SERVICE INFORMATION LETTER

No: SIRS/SIL-CE2-A25-01 Rev.03

NAVIGATION - STANDBY NAVIGATION SYSTEMS –

STANDBY COMPASS - LAMP CAP ASSEMBLY –

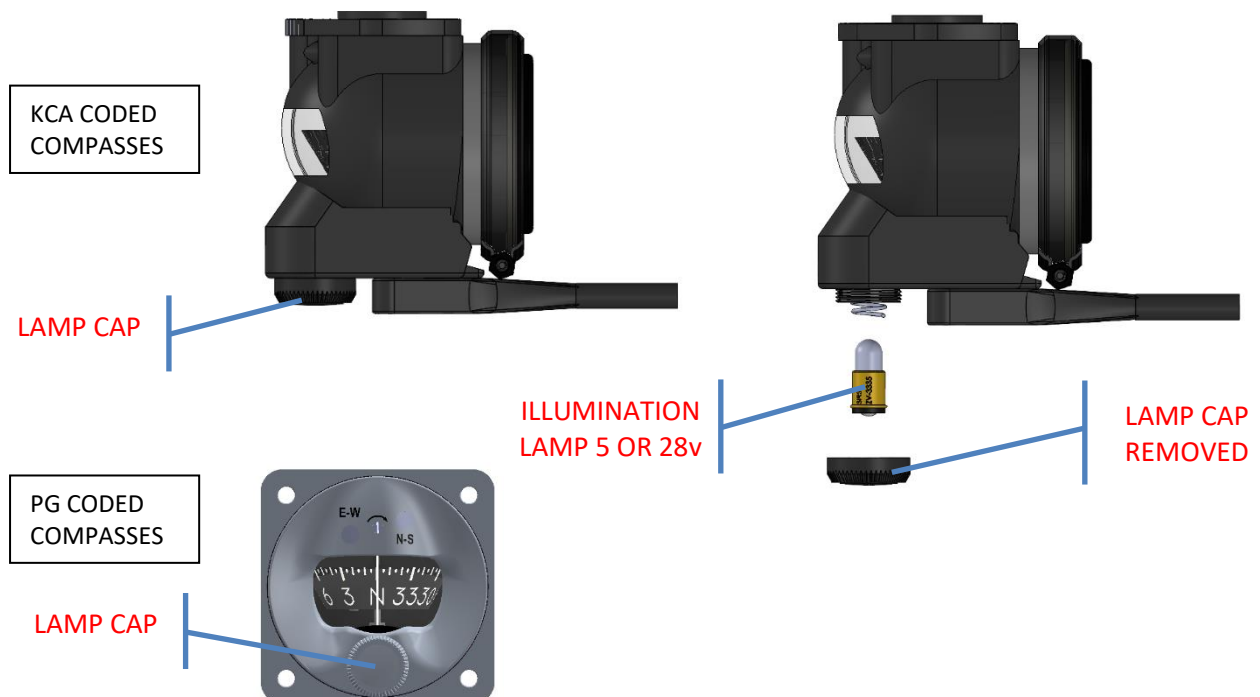
An occurrence* has been reported to SIRS whereby the removal of an illumination lamp, **without immediate replacement**, has led to the local increase in temperature to adjacent compass components with subsequent plastic deformation. The problem will only occur with the power supply switched ‘ON’ and the illumination lamp **NOT Fitted**.

The absence of the replacement lamp will cause a decrease in circuit resistance and provide a 'short circuit', with potential power demand shown within table 1.0 below.

2.0 Guidance

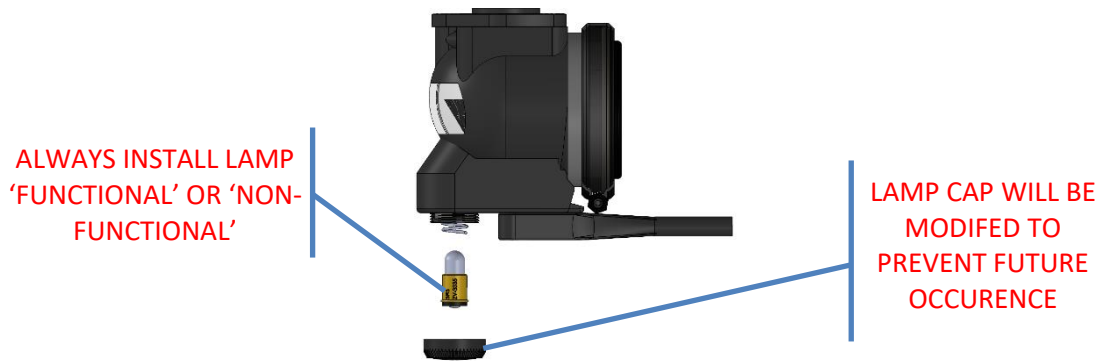
- A. **Always** include the correct lamp in the light assembly, specific to the compass part number (Functional or Non-Functional)

- B. If the lamp fails, **leave it in the assembly** until a replacement lamp can be installed.
- C. Leave the lamp assembled within the compass to prevent temperature increase.
- D. Should the compass be operated inadvertently, with the light assembly powered but without the lamp installed, power should be isolated immediately, as soon as this condition is identified. Before next flight, the compass should be removed from the aircraft and returned to SIRS.
- E. For further support **contact SIRS Navigation Ltd** to obtain additional information:

NOTE: SIRS are developing a permanent solution. A modified 'Lamp Cap Assembly' will be introduced by SIRS once approved to eliminate any further risk of 'short circuit' and 'localised increased temperature'.
